# Access Compliance Report

## Public Rights-of-Way

Intersection ID: 28642	Main Street: PADSTOW_CT	Cross Street: STEWARTS_CROSSING_DR	Location: SE
ADA ID: CA2AA54527F4	Ramp Type: BlendTrans1	Initial Pass/Fail: Fail	Overall Compliance: No
Codes/Mitigation Info/Possible Solution		Field Measurements/Component Compliance	
Severity Score: 10

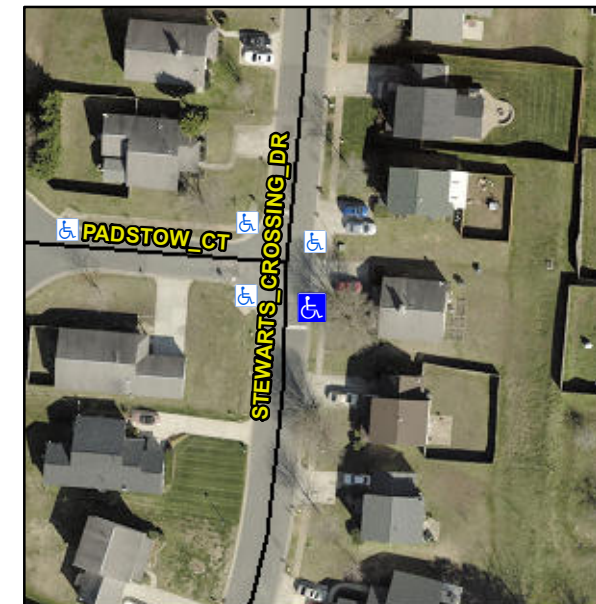
**CURB GAP 3.0**

**R304.5.1**

Compliance	Description	Data	Compliance	Description	Data
N/A	Ramp Length (in)	47.5	Yes	BlendTrans Slope (%)	1.5
No	Ramp Width (in)	45.5	Yes	BlendTrans XSlope (%)	2.3
N/A	Flare Type LT	N/A	N/A	Flare Type RT	N/A
N/A	Flare Slope LT (%)	N/A	N/A	Flare Slope RT (%)	N/A
N/A	Flare Traversable LT?	N/A	N/A	Flare Traversable RT?	N/A
N/A	Landing Length (in)	N/A	N/A	DWS Provided?	N/A
N/A	Landing Width (in)	N/A	N/A	DWS Contrast?	N/A
N/A	Landing Slope (%)	N/A	N/A	DWS Length (in)	N/A
N/A	Landing X Slope (%)	N/A	N/A	DWS Full Width?	N/A
N/A	Landing Curb? (Y/N)	N/A	N/A	DWS Offset (in)	N/A
N/A	Shared Landing?	N/A			
N/A	Gutter Ponding?	N/A	N/A	Gutter Slope (%)	N/A
N/A	Gutter Lip Ht (in)	N/A	N/A	Gutter X Slope (%)	N/A
N/A	Painted X Walk1?	No	N/A	Painted X Walk2?	N/A
	X Walk 1 Direction	To W		X Walk 2 Direction	N/A
	X Walk 1 Width (in)	N/A		X Walk 2 Width (in)	N/A
	X Walk 1 Slope (%)	3.1		X Walk 2 Slope (%)	N/A
	X Walk 1 X Slope (%)	2.6		X Walk 2 X Slope (%)	N/A

**Remove & Replace Curb Ramp With Two New Directional Ramps or Equivalent.**
